Figure 2. Trim/Tilt Cylinder Assembly.

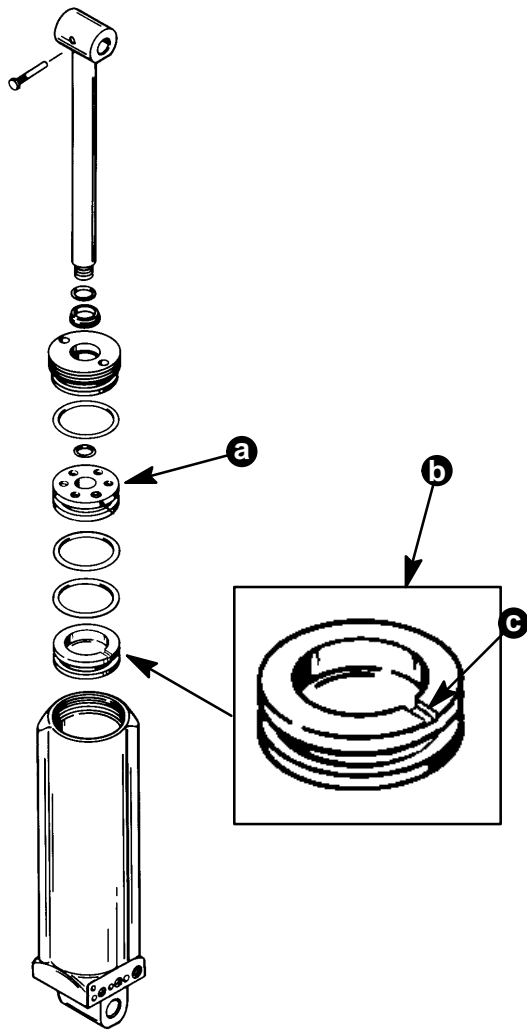
Disassemble the power trim/tilt ram assembly (refer to the service manual) and remove the memory piston. Cut a small groove .020 – .040 inch (.5 – 1 mm) deep across the top face the memory piston (figure 2). The groove will allow oil passage when the shock piston and memory piston are in contact. The groove can be easily created with a hacksaw or triangular file. Remove all burrs and filings from the memory piston. Reassemble the trim/tilt ram assembly using new O-rings and seals.

a - Shock Piston.

b - Memory Piston.

c - .020 – .040 Inch (.5 – 1 mm) Groove.

The shock piston has a groove to allow fluid passage beginning with power trim date code 14183 and estimated serial number 0G152529. The memory piston remains the same and does not have a groove across the face.
